File No. 170750 Committee Item No. 5
 Board Item No. 24

1 [General Plan Amendments - One Oak Street Project]

2
3 **Ordinance amending the General Plan by revising the height and bulk designations for**
4 **the One Oak Street project, at the Van Ness Avenue / Oak Street / Market Street**
5 **Intersection, Assessor's Parcel Block No. 0836, Lot Nos. 001 and 005, on Map 3 of the**
6 **Market and Octavia Area Plan and on Map 5 of the Downtown Area Plan; adopting**
7 **findings under the California Environmental Quality Act; making findings of**
8 **consistency with the General Plan as proposed for amendment, and the eight priority**
9 **policies of Planning Code, Section 101.1; and adopting findings of public necessity,**
10 **convenience, and welfare under Planning Code, Section 340.**

RE: Appeal Timeliness and Standing Determination – 1500-1540 Market (One Oak Project), Planning Department Case No. 2009.0159E

(NEW) FIGURE 2.17: REVISED OAK PLAZA, PLAN

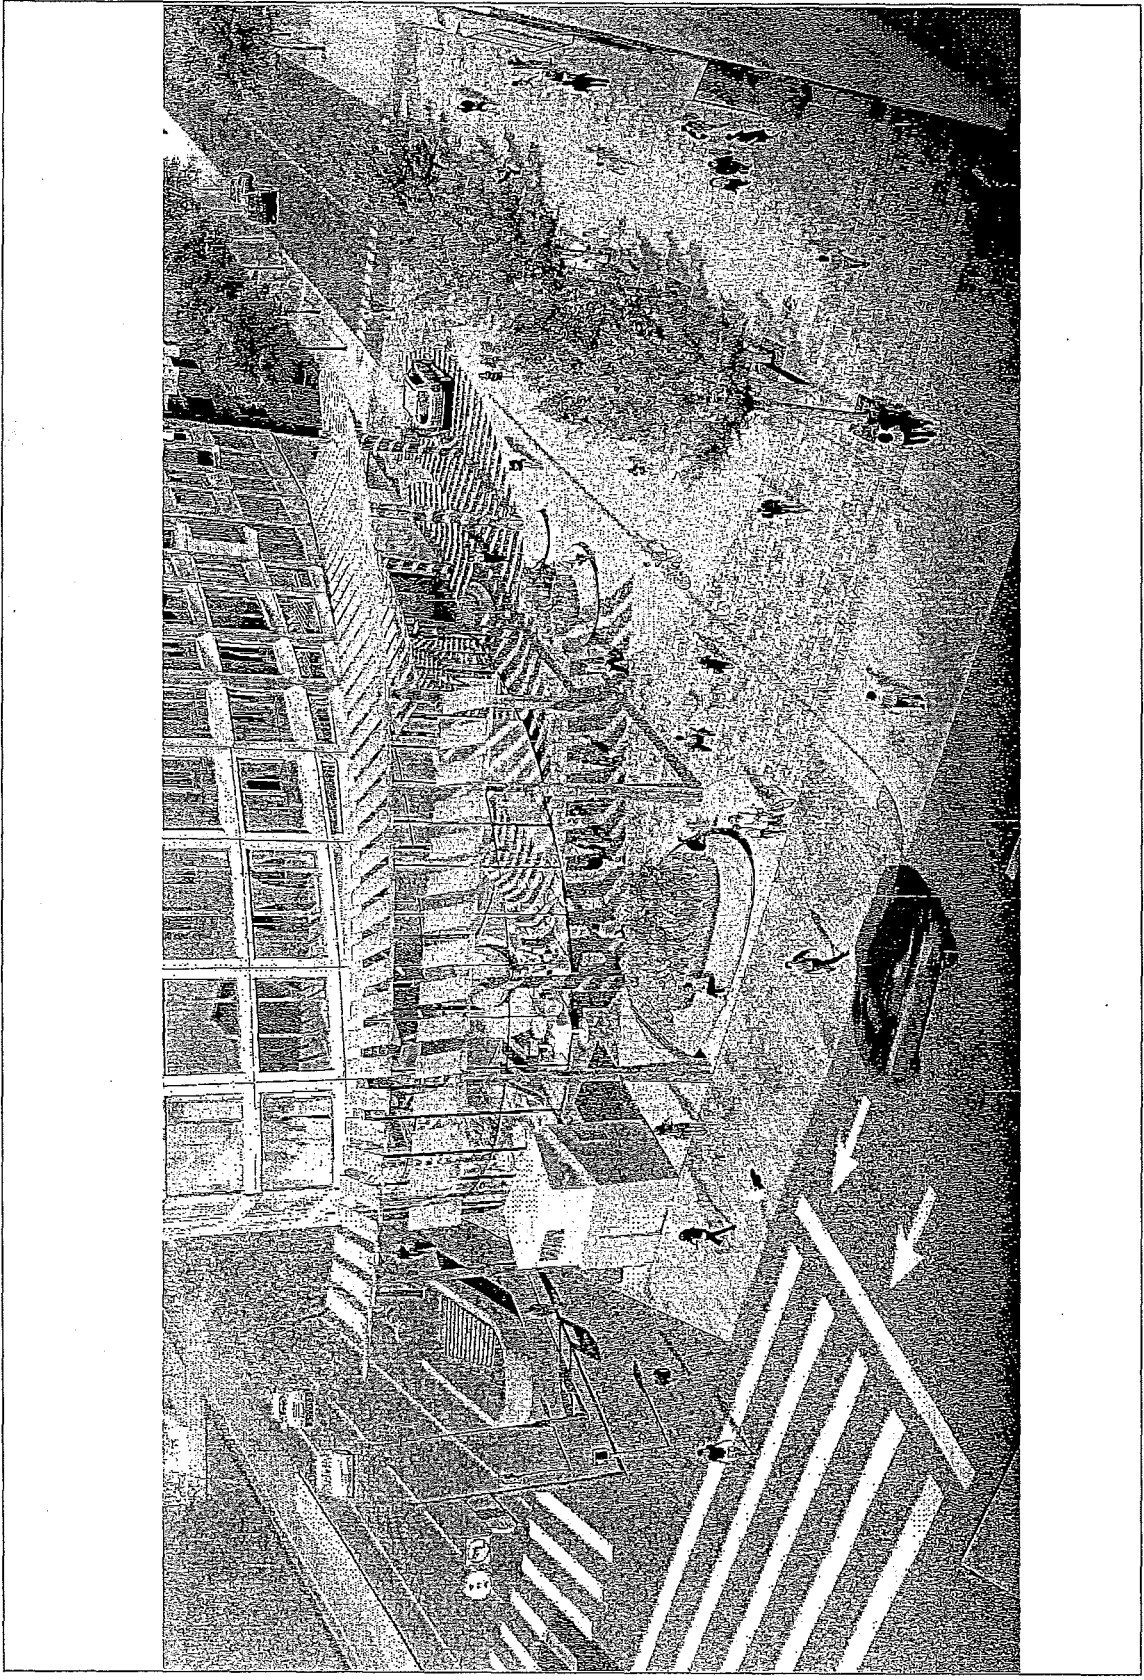
In its selection of the variant as the preferred project, the project sponsor has provided updated details and design refinements for Oak Plaza, in conformity with the *Better Streets Plan* and in response to input from the Department of Public Works. See new **Figure 2.17: Revised Oak Plaza, Plan**, and new **Figure 2.18: Revised Oak Plaza, Rendering**, shown on the following pages. Revised features for Oak Plaza under the preferred project are described below.

The design of the Oak Plaza wind canopies has been revised under the preferred project. See new Figure 2.17 on RTC p. 2.4. The revised canopies under the preferred project would consist of

FIGURE RTC-1: AREA PLANS AND PLANNING AREAS NEAR THE ONE OAK PROJECT SITE

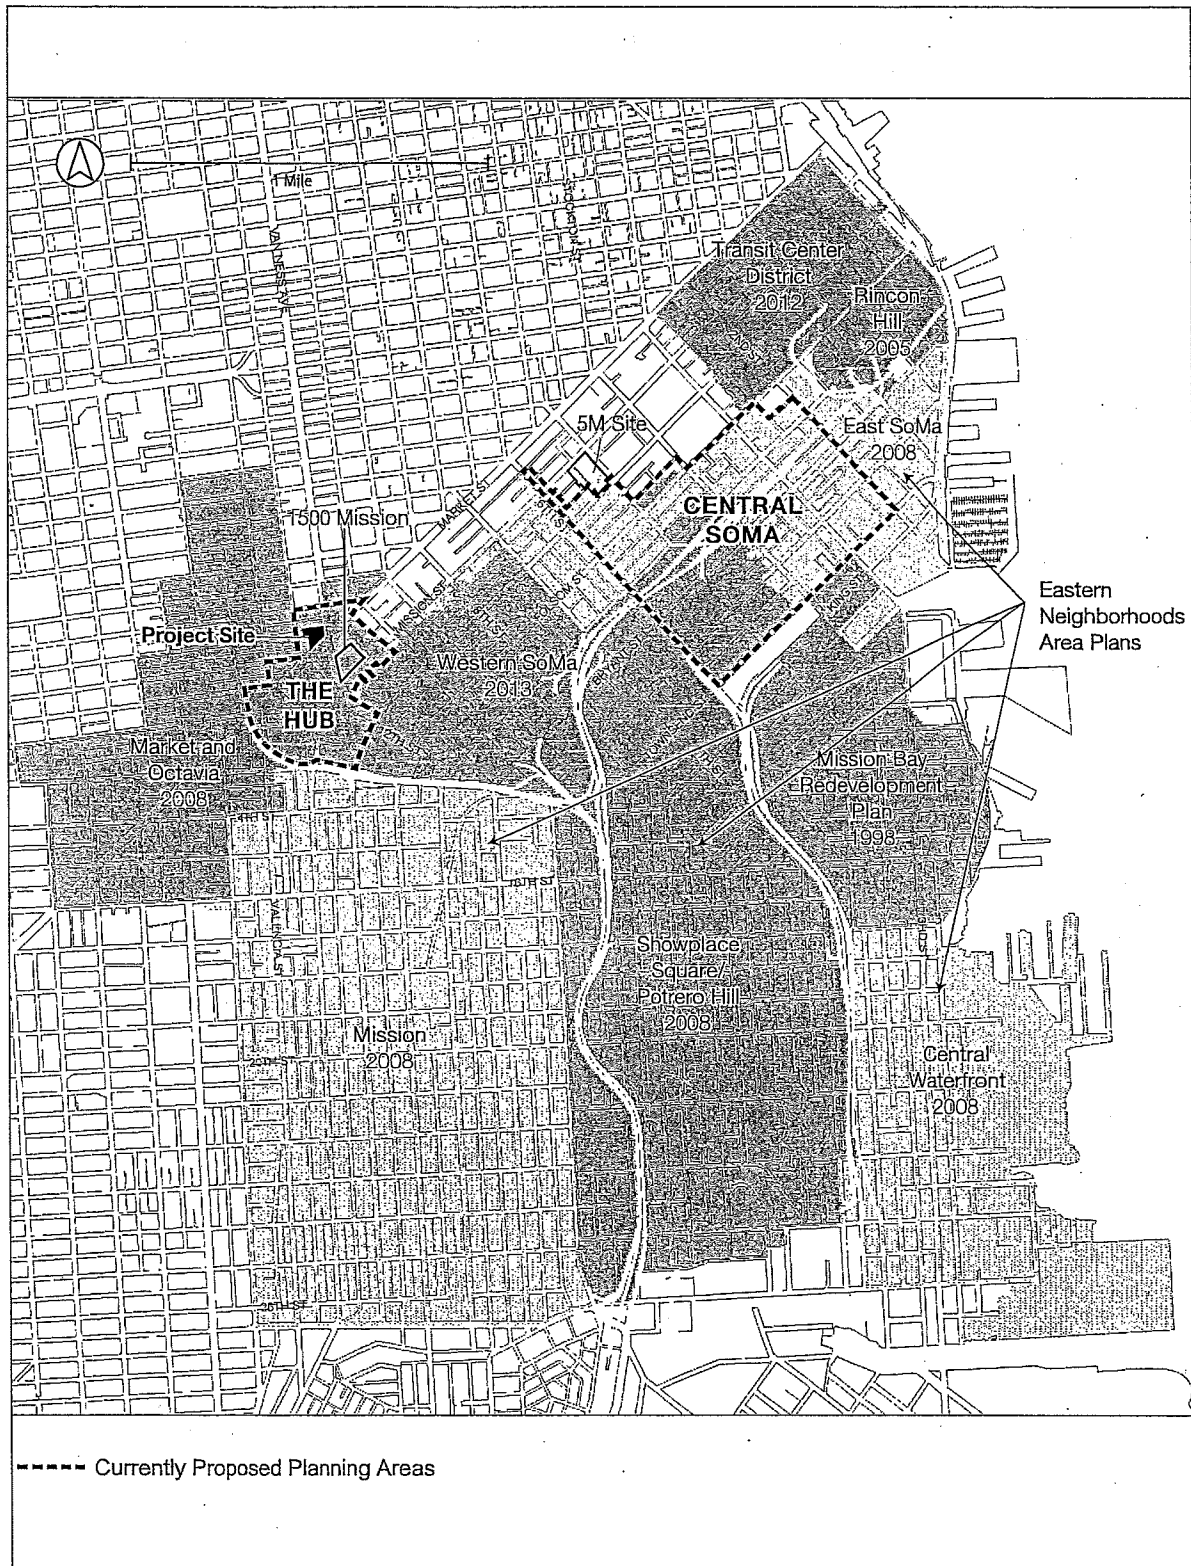
Figure RTC-1: Area Plans and Planning Areas Near the Oak Street Project Site, shows the recently adopted area plans, including the Market & Octavia Area Plan (adopted in 2008), the four Eastern Neighborhoods plans (Mission, Showplace Square/Potrero Hill, Central Waterfront, East SoMa) (adopted in 2008), the Western SoMa Plan (adopted in 2013), Rincon Hill Plan (updated plan adopted in 2005), and Transit Center District Plan (adopted in 2012). The figure also shows the area of the proposed Central SoMa Plan and the area covered by the proposed Hub planning effort. The nearby-proposed (1500 Mission Street Project, Case No. 2014-000362ENV) site is also shown, as is the approved 5M Project site. Each of these plans contains parking maximums, rather than parking minimums.

The EIR’s analysis of Land Use is adequate under CEQA because a sufficient description of existing uses was provided to establish that the addition of the proposed uses would not result in a significant land use impact applying the applicable significance thresholds. The inclusion of the requested additional details about the MO Plan, the *Western SOMA Plan*, the Van Ness and Market Downtown Residential Special Use District, the proposed *Central SoMa Area Plan*, required residential parking in the area, and the proposed Hub Project is not necessary for an

FIGURE RTC-2: REGIONAL FREEWAY FACILITIES

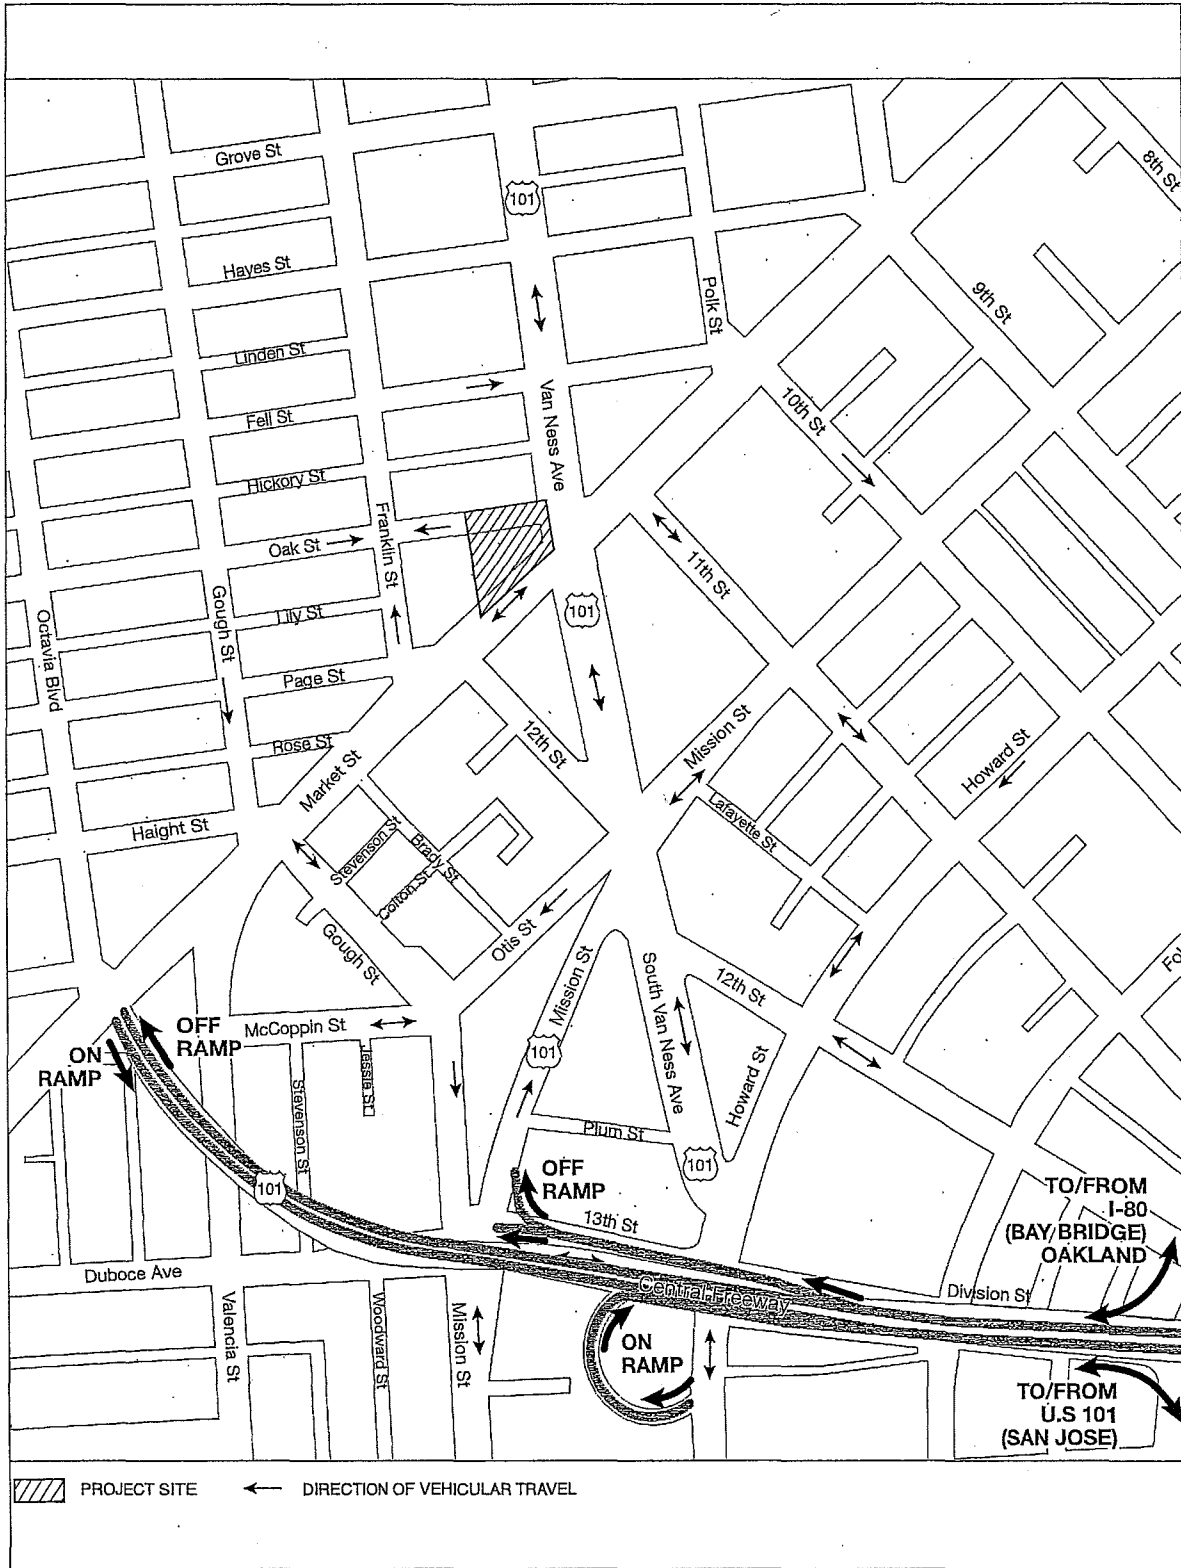
“A MAP of the freeway access and ramps will help understand travel patterns and possible impacts. And direct attention to the excessive parking provided in this "TRANSIT RICH" area. There is a freeway off ramp AT THE CORNER to the right of the Planning Department. There is an on ramp at South Van Ness and 13th. There is a Central Freeway ramp BEHIND the Planning Department. (*Sue C. Hestor, Letter, January 10, 2017 [I-Hestor2-4]*)

The comment requests a map presenting the nearby freeways access ramps. **Figure RTC-2: Regional Freeway Facilities**, presented on the next page, identifies the regional freeway connections in the vicinity of the project site. The project site is about 1,600 feet east of the U.S. 101 ramps at Octavia Boulevard, 1,900 feet north of the U.S. 101 off-ramp at Mission Street, and 2,200 feet north of the U.S. 101 on-ramp at South Van Ness Avenue. Access between the project site and the freeway facilities is described on EIR pp. 4.C.1-4.C.2, and therefore the EIR text does not need to be amended to state that the freeway ramps are used to enter and exit San Francisco.

(REVISED) FIGURE 2.3: PROPOSED GROUND FLOOR PLAN

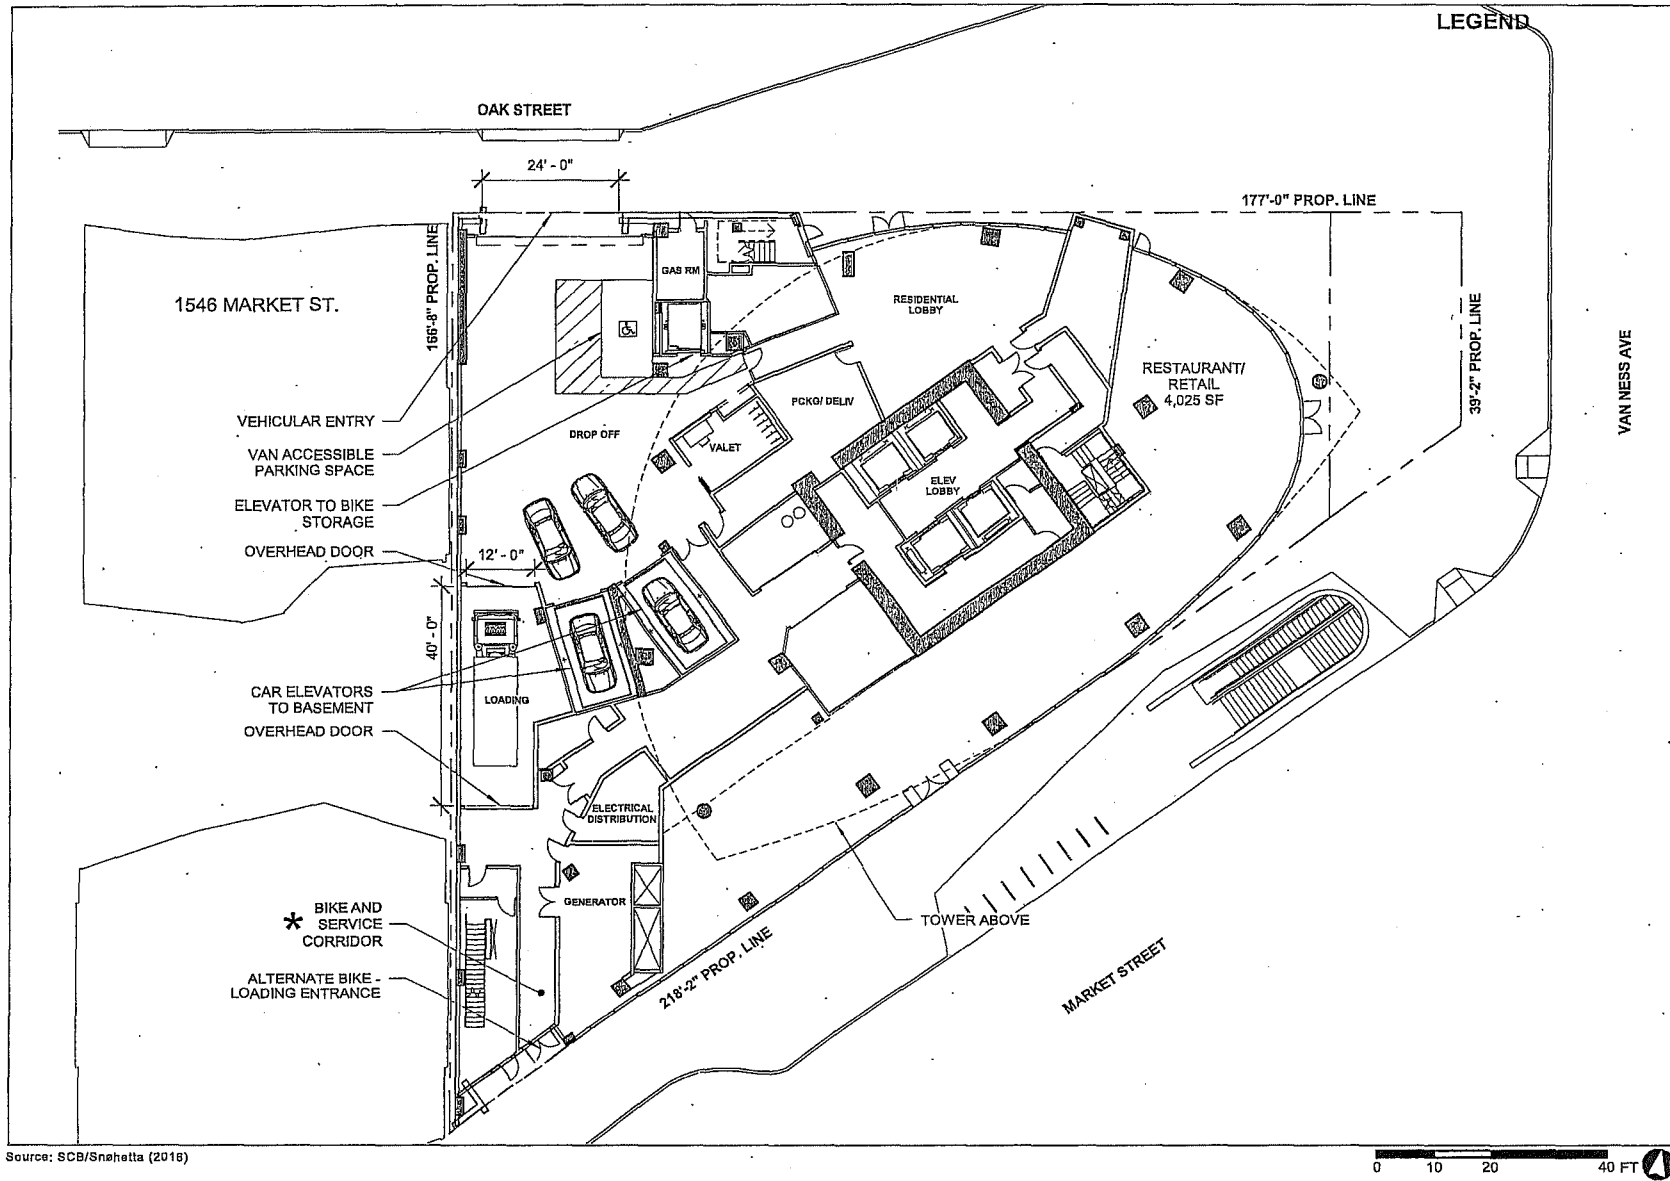
- * Figure 2.3: Proposed Ground Floor Plan, on p. 2.8, has been revised to change the label for “Loading and Bike Corridor” to “Bike and Service Corridor.” The revised figure is shown on the following page.

(NEW) FIGURE 2.17: REVISED OAK PLAZA, PLAN

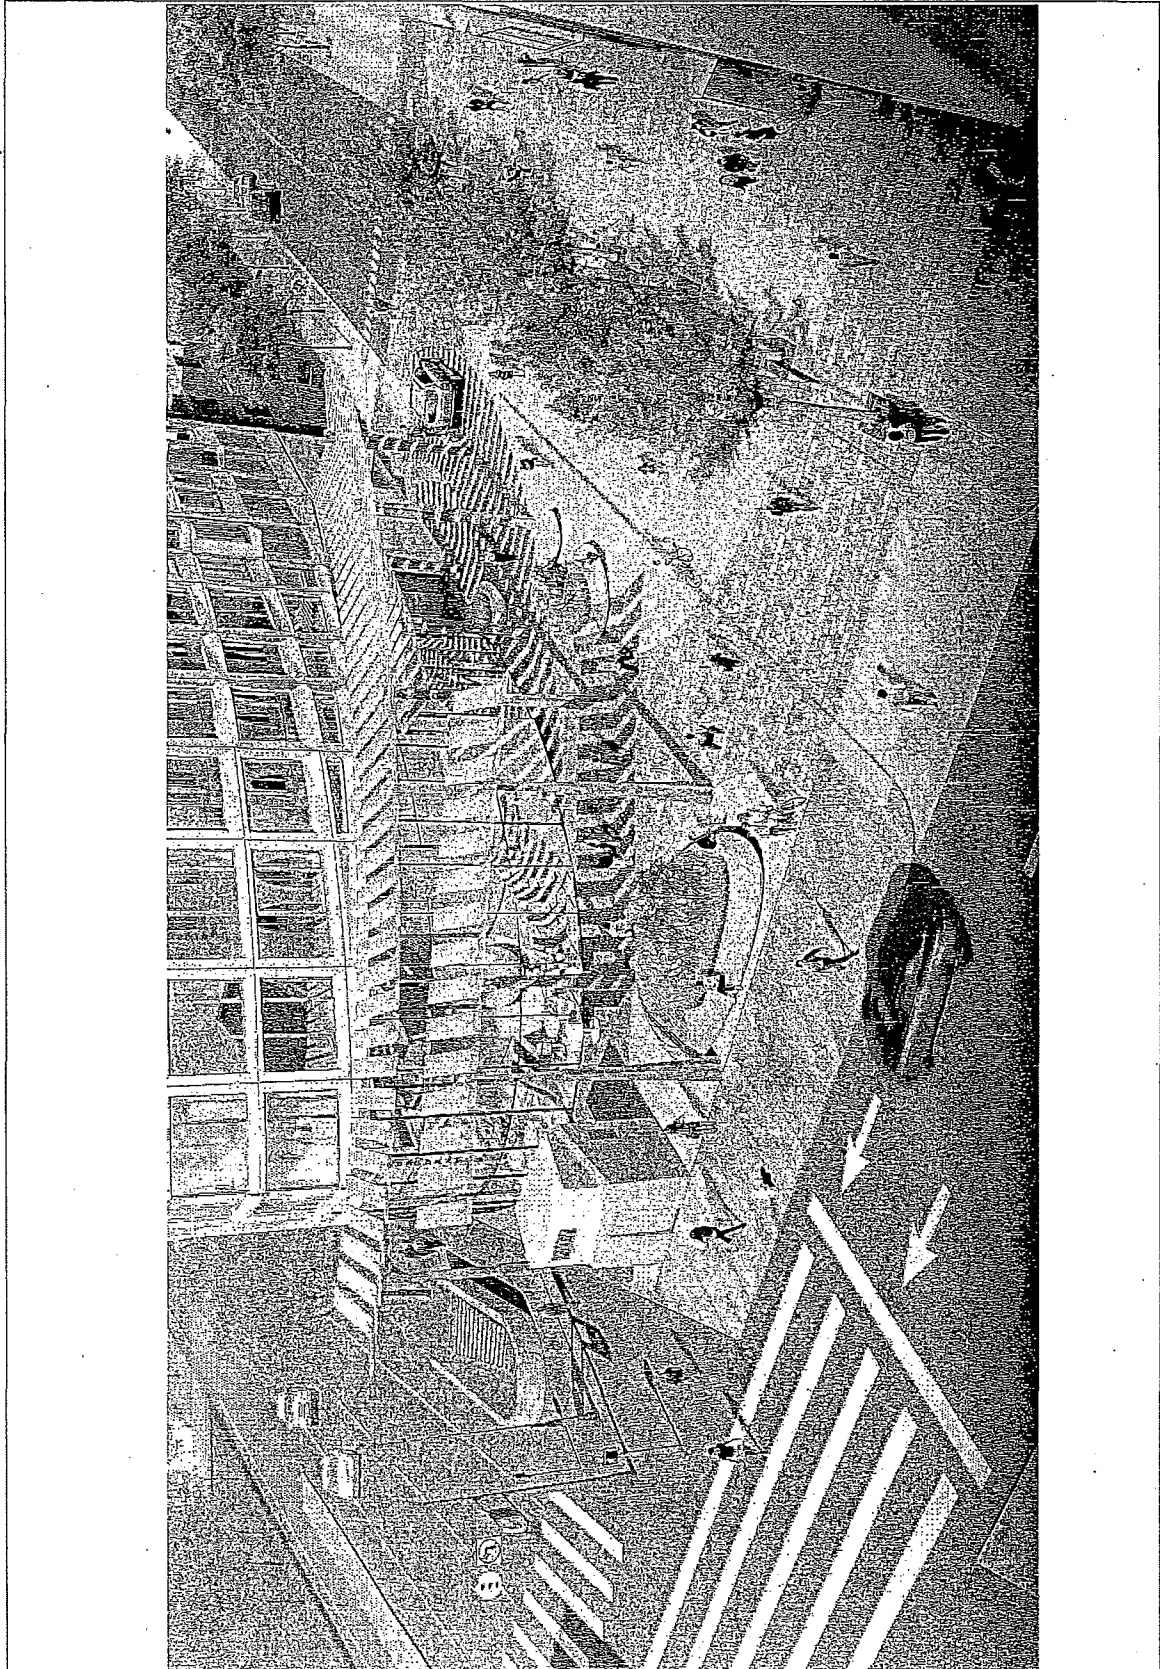
- * The following new text has been added after the last paragraph on p. 2.30 (new text is underlined). This change also introduces two new figures that have been added to Chapter 2: Figure 2.17: Revised Oak Plaza, Plan, and new Figure 2.18: Revised Oak Plaza, Rendering.

In its selection of the variant as the preferred project, the project sponsor has provided updated details and design refinements for Oak Plaza, in conformity with the *Better Streets Plan* and in response to input from the Department of Public Works. See new **Figure 2.17: Revised Oak Plaza, Plan**, and new **Figure 2.18: Revised Oak Plaza, Rendering**, shown on the following pages. Revised features for Oak Plaza under the preferred project are described below.
